**CONCEPT PLAN REVIEW: HILLMONT (Project #22-004)**

**SUMMARY REPORT**

<b>PROPERTY ADDRESS</b> 138 Stancell Drive	<b>MEETING DATE</b> April 6, 2022	<b>APPLICANT</b> McAdams, on behalf of Northwood Ravin
---	--------------------------------------	---

## Stormwater Management Master Plan (Excerpt)

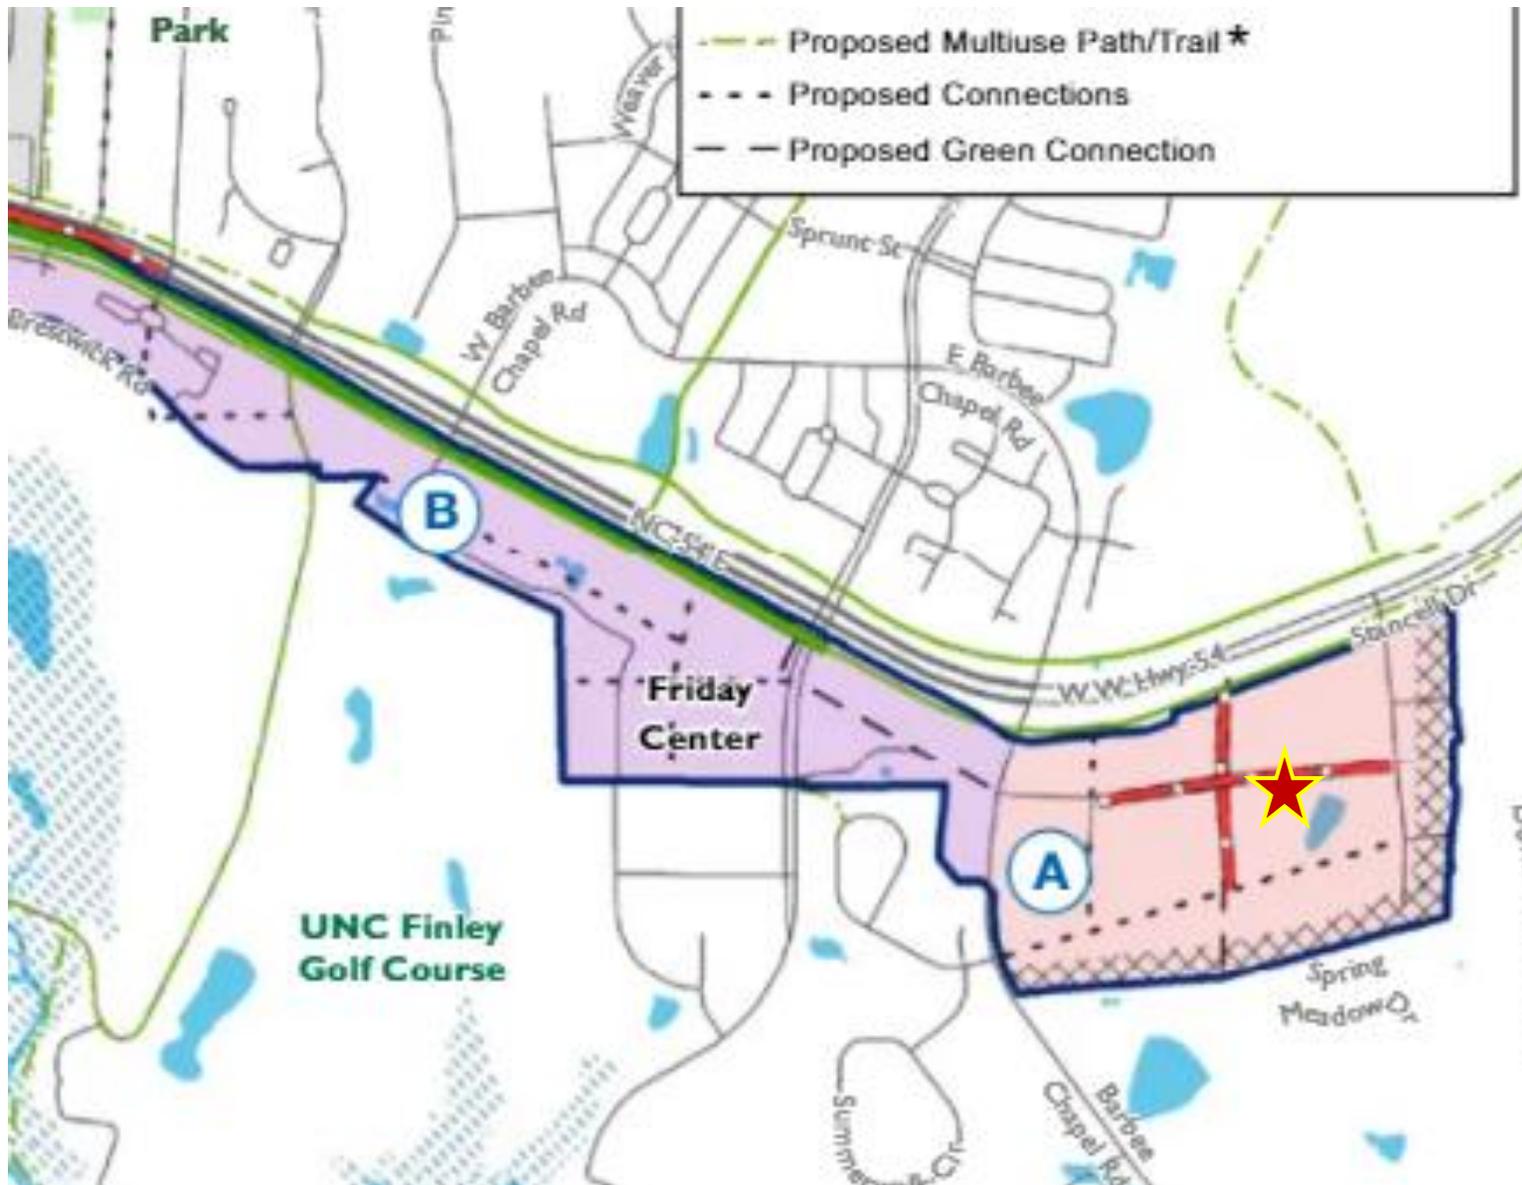
- The site is mostly located in the Little Creek Arm Subwatershed, with an eastern portion of the site located in the Cedar Fork Subwatershed (BL8). The applicant should **coordinate with Chapel Hill's Stormwater Management Division** to understand relevant stormwater considerations.

Greenways Master Plan (Excerpt)

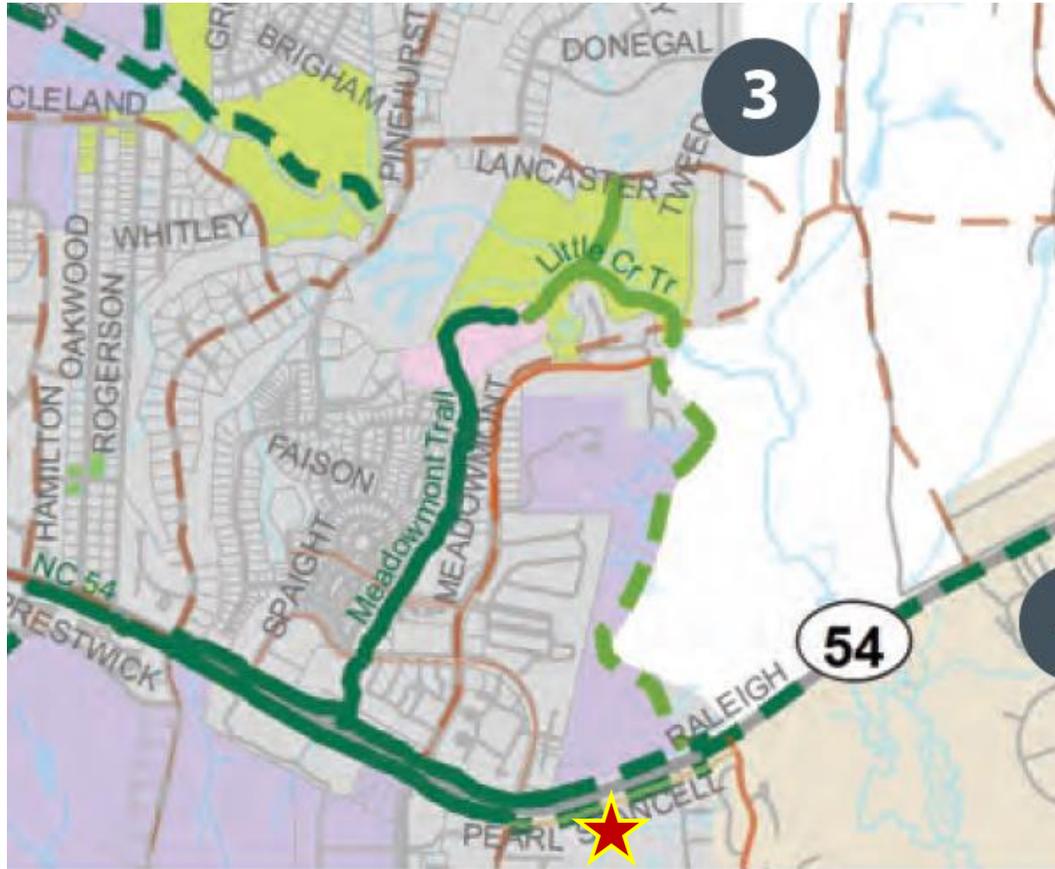
- Proposed paved, north side of site along NC-54.
- The applicant should **coordinate with Chapel Hill Parks & Recreation** for the latest information on trail alignment, design, and construction timing.
